Town of Fort Myers Beach

Project Name: MATANZAS INN & RESORT CPD AMENDMENT
Authorized Applicant: MURPHY PLANNING
LeePA STRAP Number(s): 19-46-24-W4-0150E.0210, 24-46-23-W3-00202.0130, 24-46-23-W3-00202.0150

MASTER CONCEPT PLAN
 MATANZAS INN
 REDEVELOPMENT

Re: DCI2013-0002 Matanzas Inn CPD Amendment

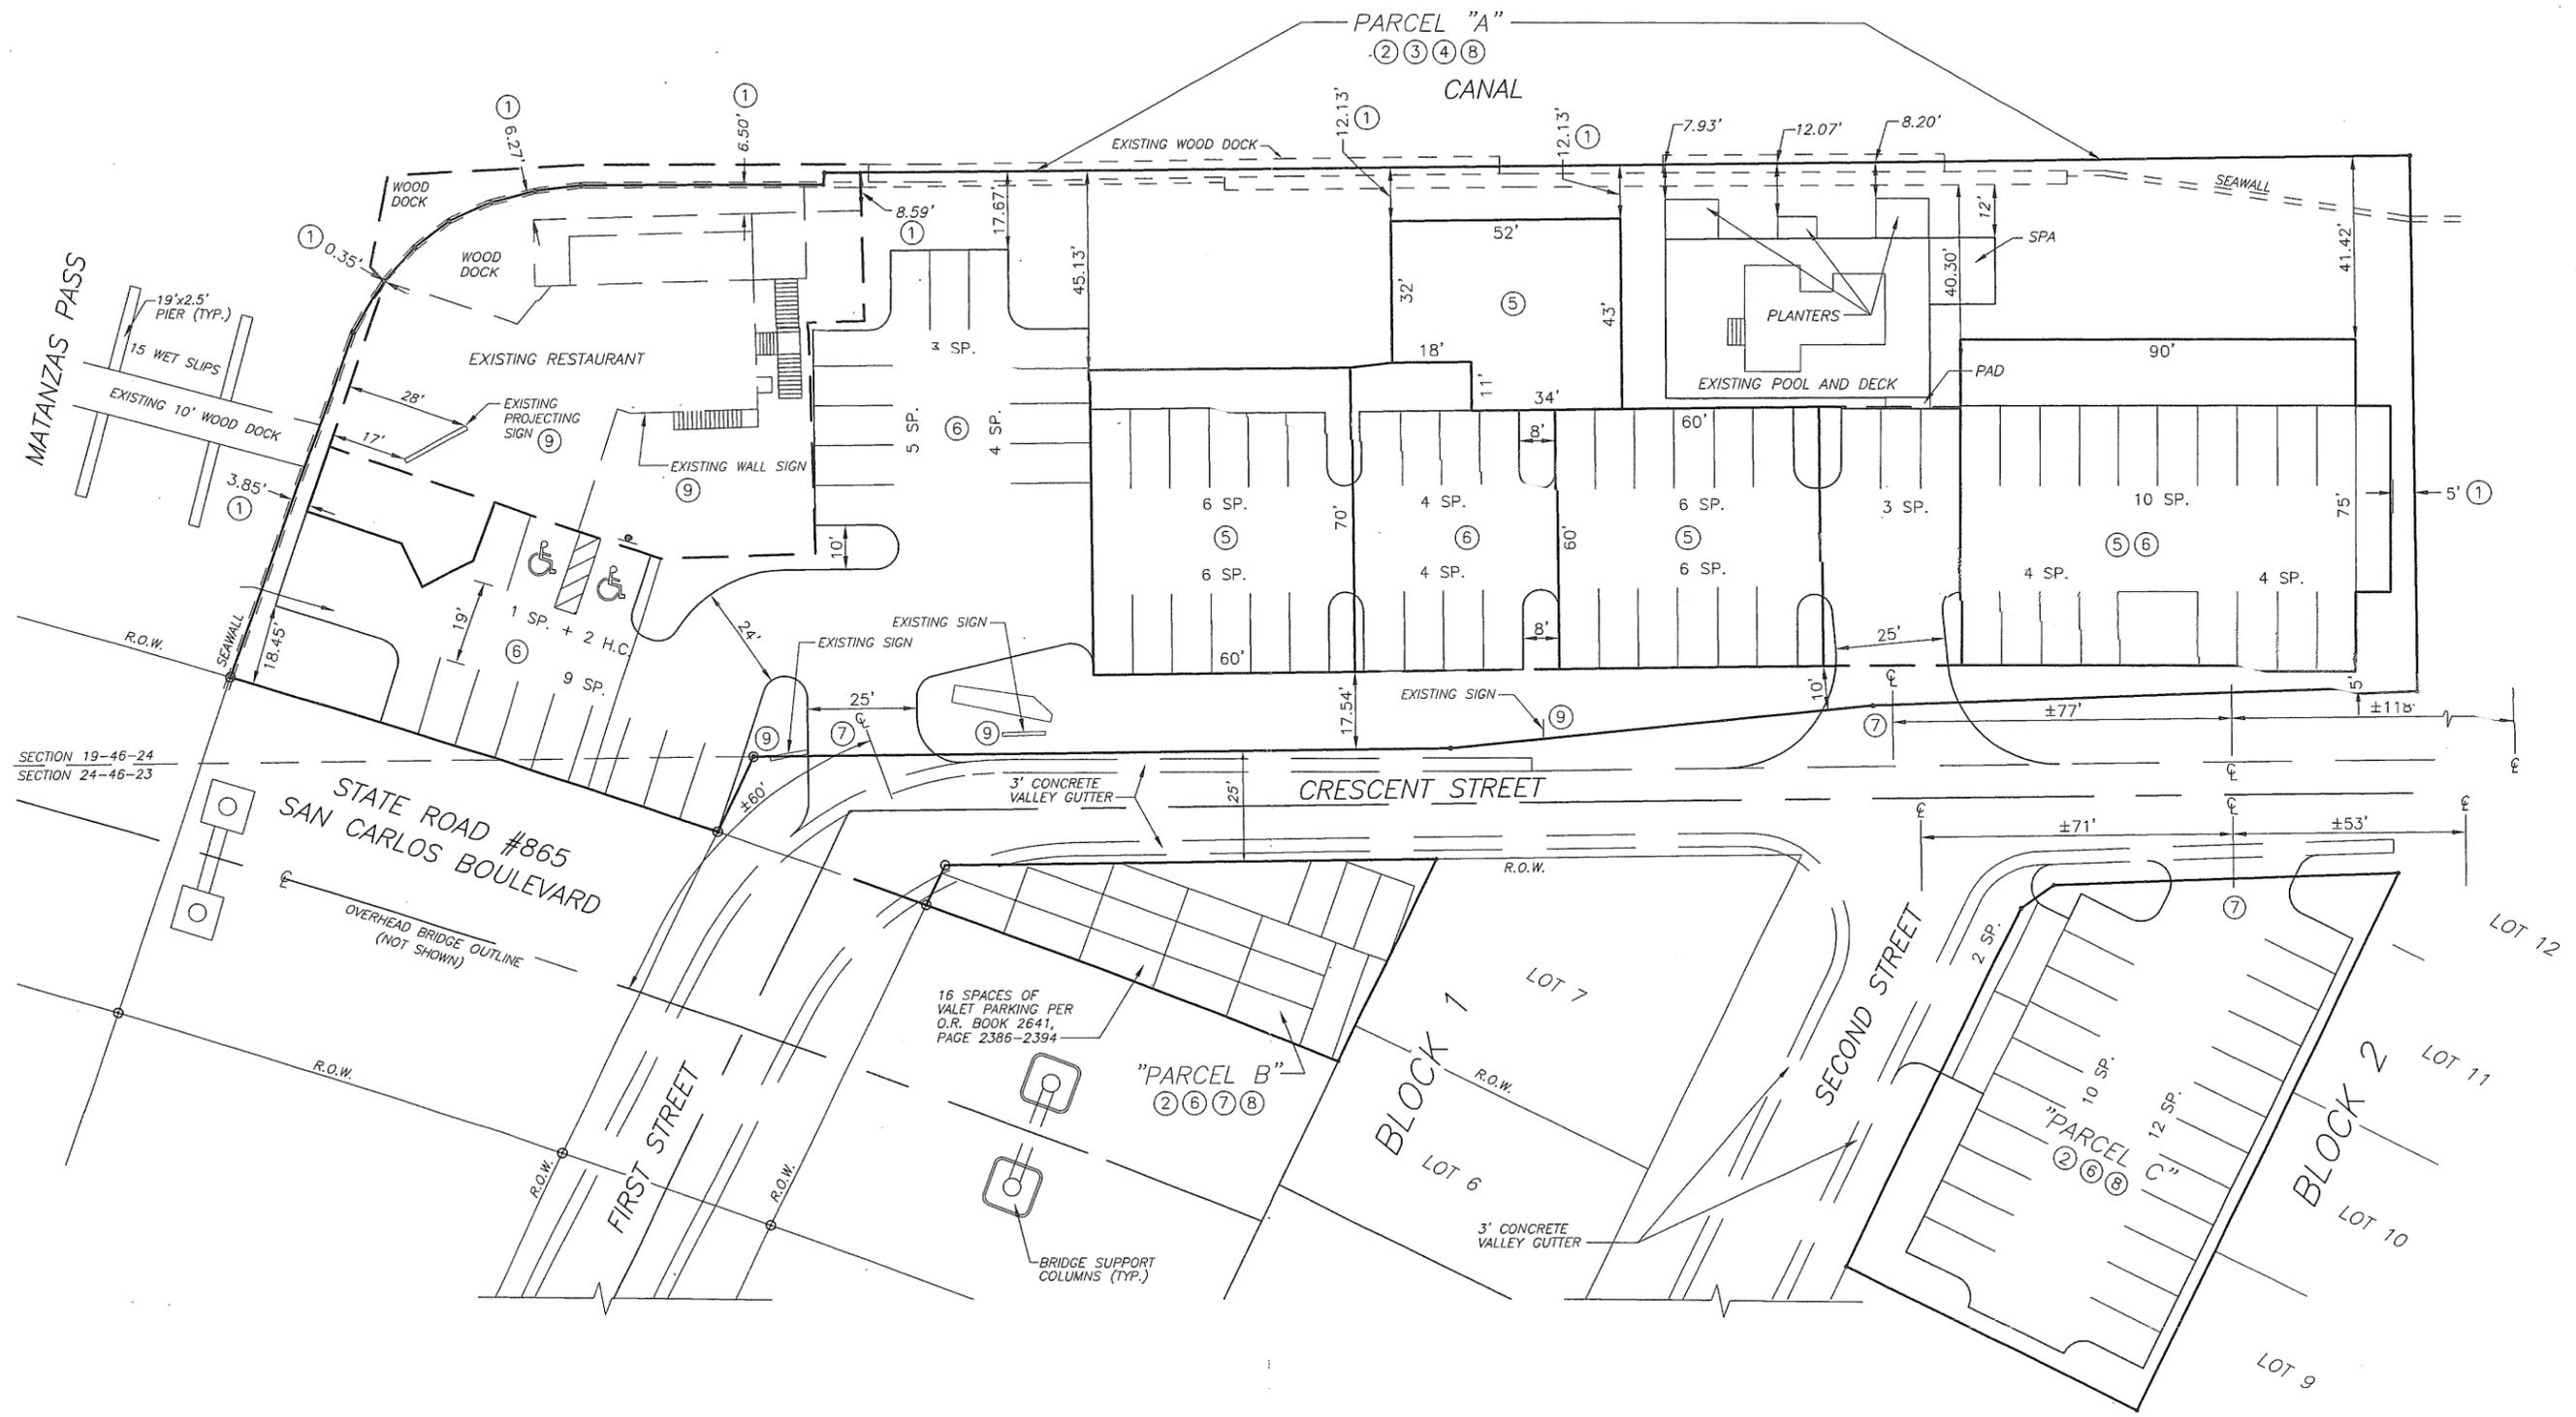
Please include a Phasing Plan, either on the Master Concept Plan or a separate drawing, identifying and indicating the scope of each Phase.

Staff does not see where the open space and buffers are delineated on Parcel A, Parcel B or Parcel C on the MCP submitted with this application. Additionally Staff is concerned with the lack of buffering indicated for Parcel C and to a lesser extent Parcel B. These parcels abut existing residential uses and should have buffers provided. Please revise the MCP to indicate these areas or provide a landscape betterment plan that illustrates compliance.

Please include a Phasing Plan, either on the Master Concept Plan or a separate drawing, identifying and indicating the scope of each Phase.

Please label and indicated areas for required buffers or provide a landscape betterment plan indicating compliance with required landscaping and buffers.

Please provide parking calculations.

Please label the included photographs and elevation as to where they relate on the Master Concept Plan.
